Office Action Summary	Application No. 10/599,053	Applicant(s) GRAMMELSBERGER, AXEL	
	Examiner /ROBERT J. POPOVICS/	Art Unit 1778

DETAILED ACTION

(19) United States		(10) Pub. No.: US 2011/0139703 A1	
(13) Patent Application Publication		(43) Pub. Date: Jun. 16, 2011	
(12) GRAMMELSBERGER			
(54) SCREENING GRID		Publication Classification

Drawings

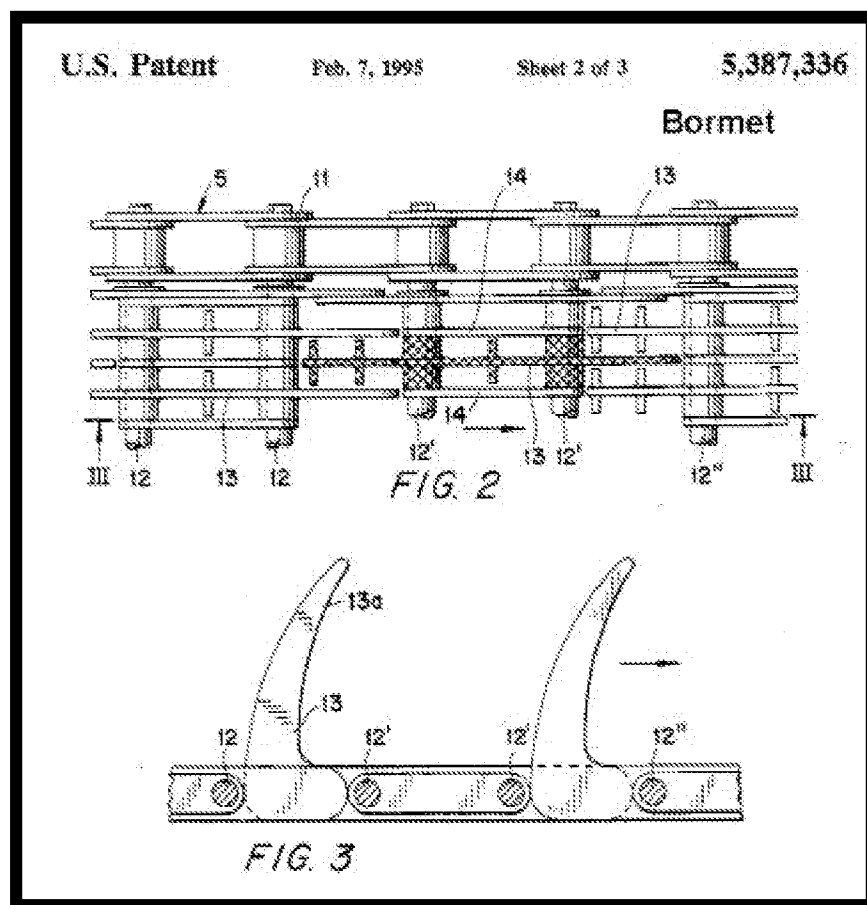
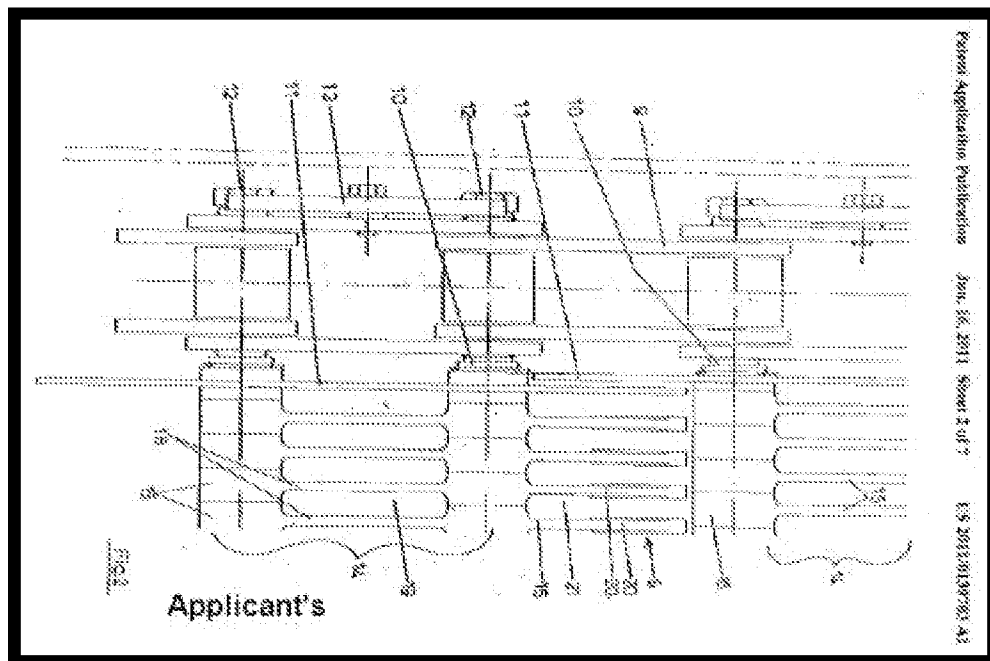
The drawings are objected to because **it is not clear from the drawings which parts are solid and which parts are voids (compare Applicant's Figures with those of Bormet below). Applicant's drawings lack the shading and other drawing conventions that permits those skilled in the art to discern the solid structure from the voids. Additionally, the drawings are objected to because they contain copier marks (e.g., black specs, blemishes, etc.) throughout, or are of poor line quality.** Corrected drawing sheets in compliance with 37 CFR 1.121(d) are required in reply to the Office action to avoid abandonment of the application. Any amended replacement drawing sheet should include all of the figures appearing on the immediate prior version of the sheet, even if only one figure is being amended. The figure or figure number of an amended drawing should not be labeled as "amended." If a drawing figure is to be canceled, the appropriate figure must be removed from the replacement sheet, and where necessary, the remaining figures must be renumbered and appropriate changes made to the brief description of the several views of the drawings for consistency. Additional replacement sheets may be necessary to show the renumbering of the remaining figures. Each drawing sheet submitted after the filing date of an application must be labeled in the top margin as either "Replacement Sheet" or "New Sheet" pursuant to 37 CFR 1.121(d). If the changes are not accepted by the examiner, the applicant will be notified and informed of any required corrective action in the next Office action. The objection to the drawings will not be held in abeyance.

The drawings are objected to under 37 CFR 1.83(a). The drawings must show every feature of the invention specified in the claims. Therefore, ***"wherein all screening links having projecting parts that extend only in one direction,"*** must be shown or the feature(s) canceled from the claim(s). No new matter will be entered.

Corrected drawing sheets in compliance with 37 CFR 1.121(d) are required in reply to the Office action to avoid abandonment of the application. Any amended replacement drawing sheet should include all of the figures appearing on the immediate prior version of the sheet, even if only one figure is being amended. The figure or figure number of an amended drawing should not be labeled as "amended." If a drawing figure is to be canceled, the appropriate figure must be removed from the replacement sheet, and where necessary, the remaining figures must be renumbered and appropriate changes made to the brief description of the several views of the drawings for consistency. Additional replacement sheets may be necessary to show the renumbering of the remaining figures. Each drawing sheet submitted after the filing date of an application must be labeled in the top margin as either "Replacement Sheet" or "New Sheet" pursuant to 37 CFR 1.121(d). If the changes are not accepted by the examiner, the applicant will be notified and informed of any required corrective action in the next Office action. The objection to the drawings will not be held in abeyance.

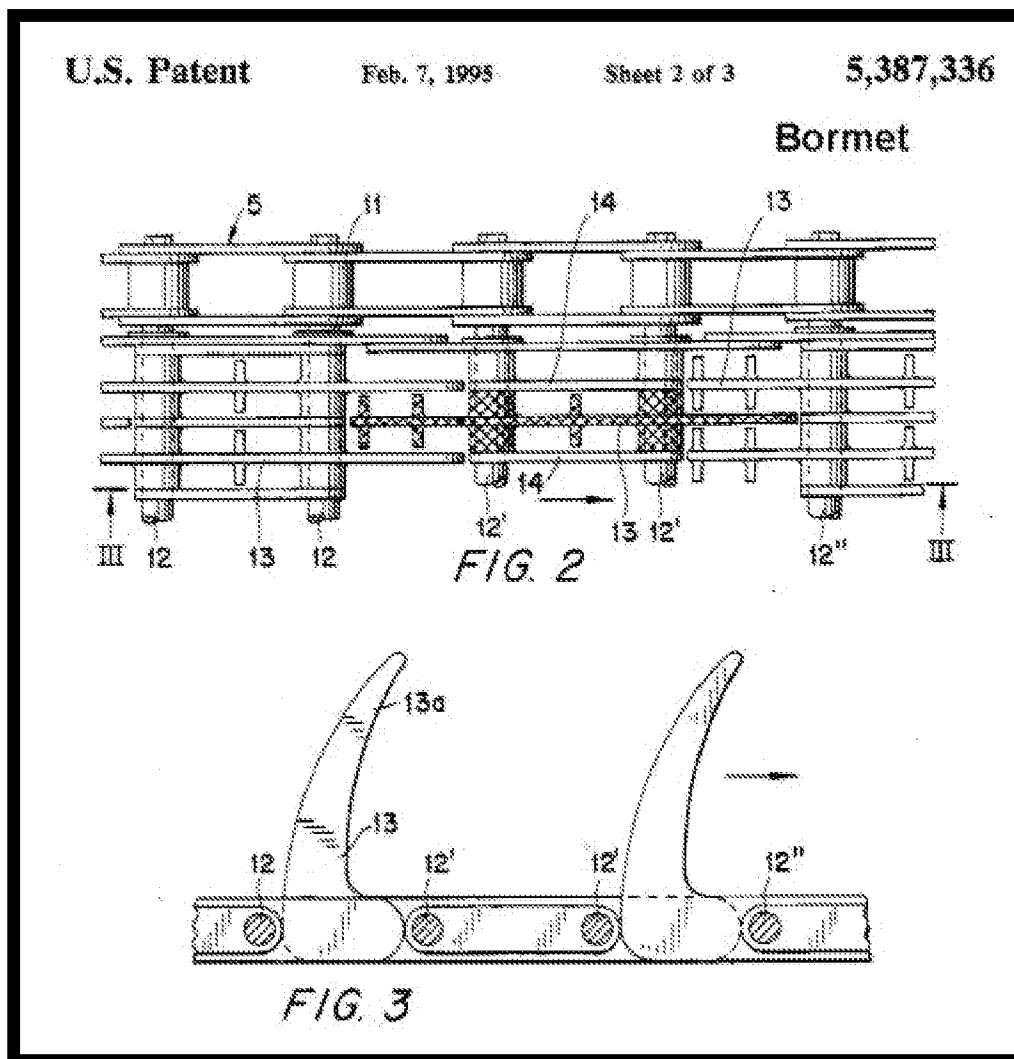
Claims **13-15** and **18** are rejected under 35 U.S.C. 102(b) as anticipated by or, in the alternative, under 35 U.S.C. 103(a) as obvious over **Bormet (US 5,387,336)**. As best understood, Bormet is seen to meet the language of the claims in that a “projecting part” having a partial hook is seen to be met by the structure depicted in Figure 3 of Bormet:
